## C2PC Letter

We, SHANTOU CHAOYANG DISTRICT SHENGTENA ELECTRONIC FACTORY apply for Class II permissive change for FCC ID: 2ALOE-ARBT255. The difference between the new sample and original one is as following:

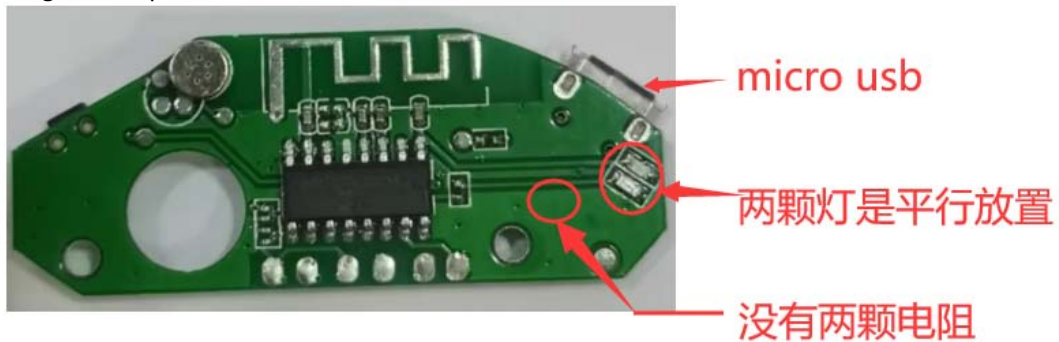
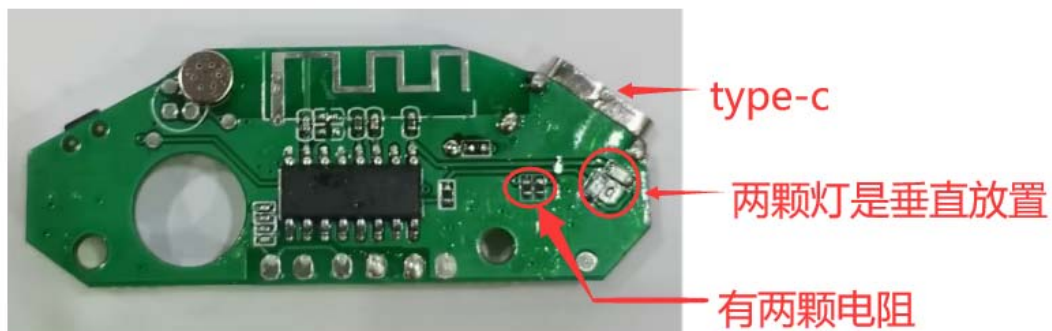
1. The Micro-USB port is changed to Type-C port
2. The LEDs (D3 and D5) is placed in vertical, while in the original application, it was placed in horizontal
3. R12 and R13 are added in this application
4. The others remain the same.
